**GLEN EIRA PLANNING SCHEME
AMENDMENT C60
(CAULFIELD VILLAGE)**

PANEL REPORT

JULY 2010

Figure 10-1 Amended Residential Precinct - Height and Setback diagram

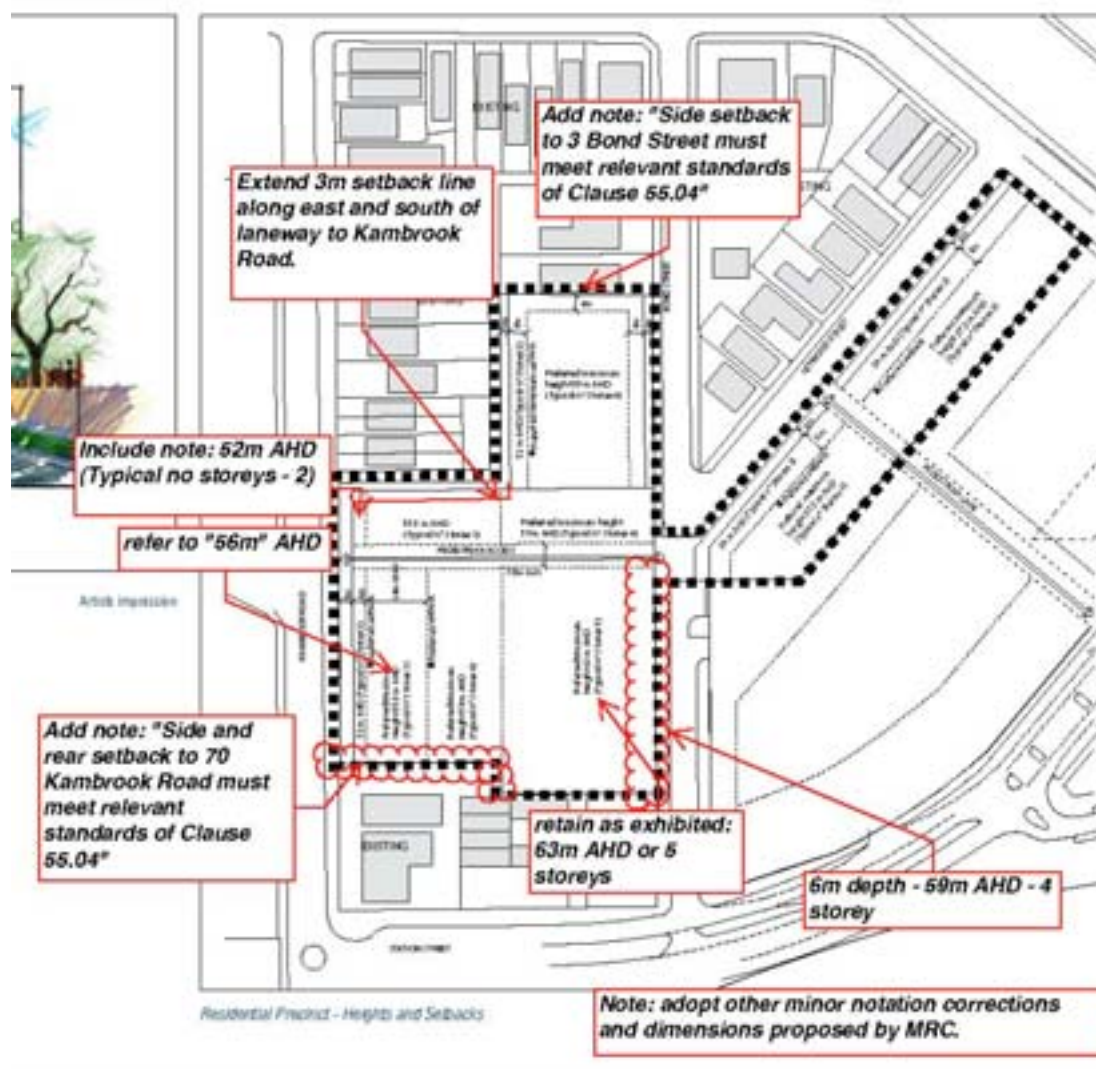
The Panel recommends the diagram be amended require ResCode standards be met where the amendment land abuts 70 Kambrook Road. However, the Panel considers this a more site responsive consideration will be required to 2 – 4 Station Street. Based on its current use and building form the Panel is satisfied that no specific setback is required as a permit trigger. The Panel therefore recommends the residential precinct plan remain as exhibited for this interface to 2 – 4 Station Street. As the Panel recommended, an amendment will be required to the mixed use precinct height and setback plan.

The Panel accepts other minor notation and clarification of the plan as proposed by the MRC and as noted in Figure 10.1 below.

- (k) Label the diagram forming part of 06 – Residential Precinct Guidelines “Height and Setback Diagram” and amend it in accordance with the notated plan in Figure 10.1 to this Panel Report.

- Label the diagram forming part of 06 – Residential Precinct Guidelines "Height and Setback Diagram" and amend it in accordance with the notated plan in Figure 10.1 to this Panel Report.

Figure 10-2 Amended Mixed Use Precinct - Height and Setback Diagram

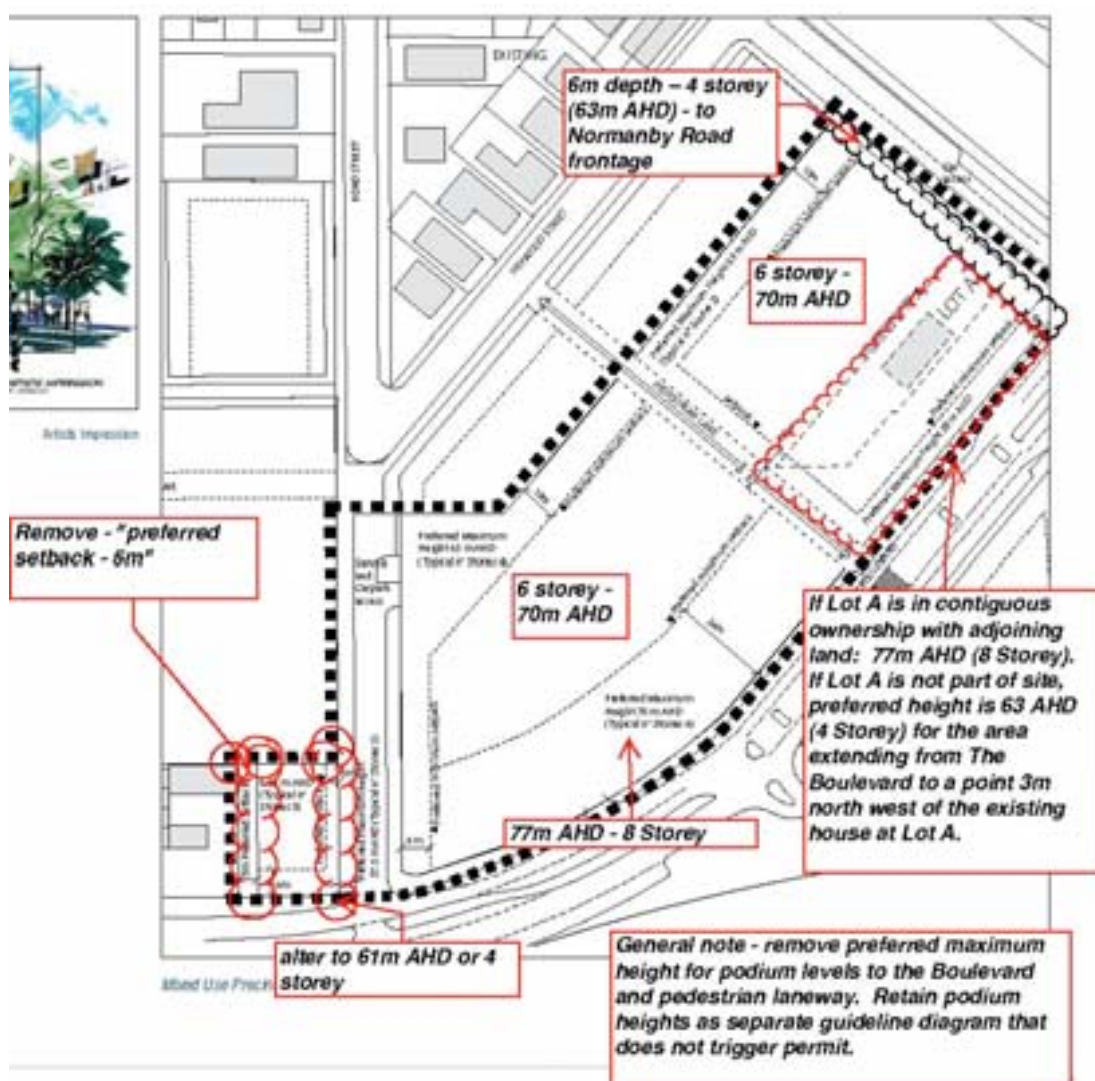
The Panel recognises that this does limit the development of the mixed use area, but only to the extent that it will require a planning permit, and therefore afford the owners of 3 Normanby Road third party review rights, until such time that the property is in contiguous ownership with the MRC land.

The Panel further recommends that this height restriction be noted on the plan so that it is clear that if the height is not met, a permit is triggered. The Panel accepts the other setback guidelines can be 'guidelines' that form part of the assessment of the development plan. The 4 storey height restriction should extend for a width of at least 3 metres west of the Perring family house. The Panel notes the diagram forming part of the Incorporated Plan suggests the house is located nearer the eastern side boundary, however, this conflicts with aerial photography and site inspection that suggests the house is only 1.2 – 1.5 m from the western side boundary. The house and title boundary needs to be correctly notated on the final adopted plan.

- (m) Label the diagram forming part of 07 – Mixed Use Precinct Guidelines as “Height and Setback Diagram” and amend it in accordance with the notated plan in Figure 10.2 to this Panel Report.

- The diagram forming part of 07 – Mixed Use Precinct Guidelines be labelled "Height and Setback Diagram" and amended in accordance with the notated plan in Figure 10.2 to this Panel Report.

Figure 10-3 Amended Smith Street Precinct - Height and Setback Diagram

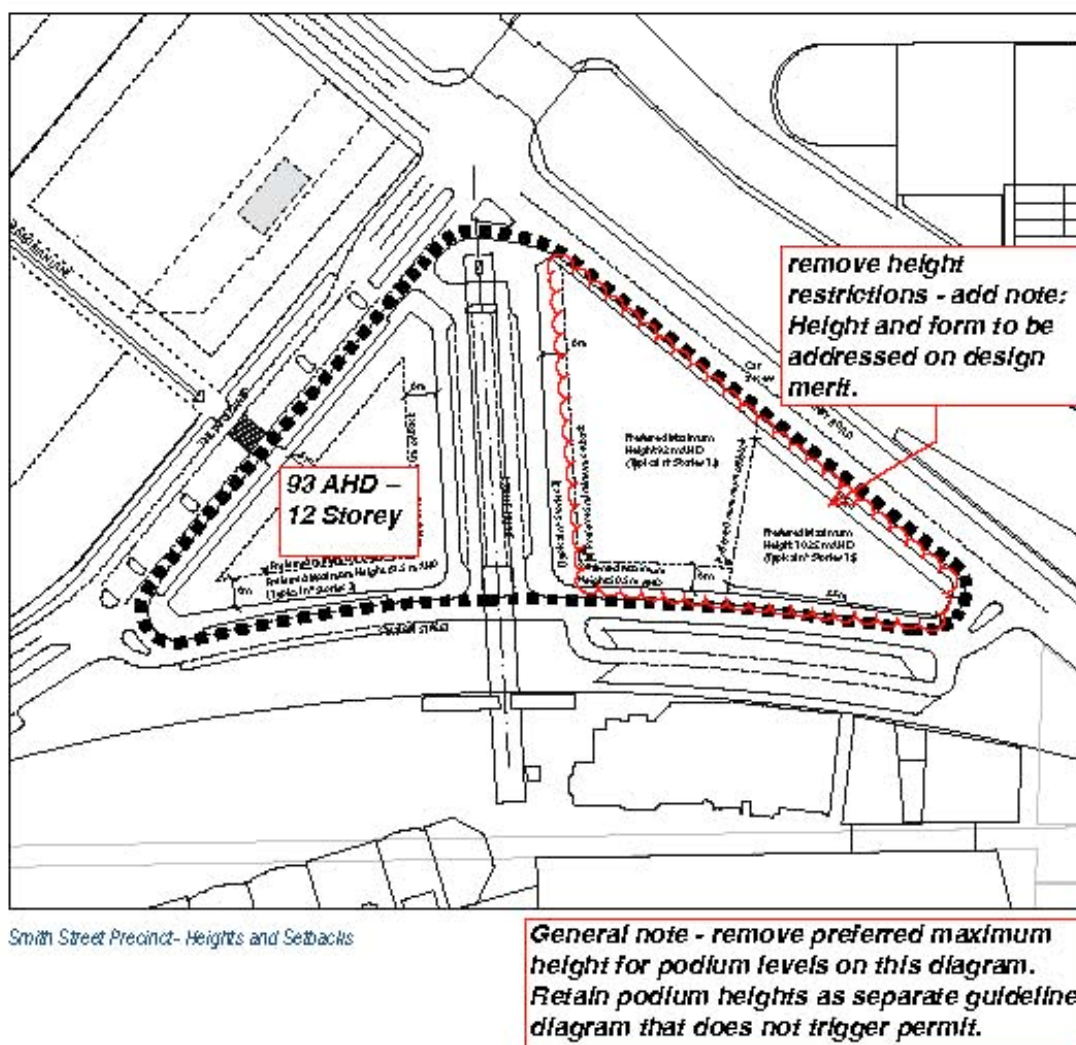
The Panel finds the design debates for the land east of the Boulevard should be only between Council and the developer, regardless of whether a podium is provided or not. If a dispute remains between these two, then the development plan can still be referred to review by VCAT via Section 149 of the Planning and Environment Act.

The Panel finds the design guidelines of the Incorporated Plan should clearly state the design intention is to establish pedestrian friendly interfaces to all streets through use of podiums or other design treatments to all street frontages (being the Boulevard, Smith Street, Normanby Road) and Station Street. This may include a separate diagram illustrating where podiums are preferred, but not part of a diagram that defines permit triggers.

- (o) Label the diagram forming part of 08 – Smith Street Precinct Guidelines “Height and Setback Diagram” and amend it in accordance with the notated plan in Figure 10.3 to this Panel Report.

- The diagram forming part of 08 – Smith Street Precinct Guidelines be labelled “Height and Setback Diagram” and amended in accordance with the notated plan in Figure 10.3 to this Panel Report.
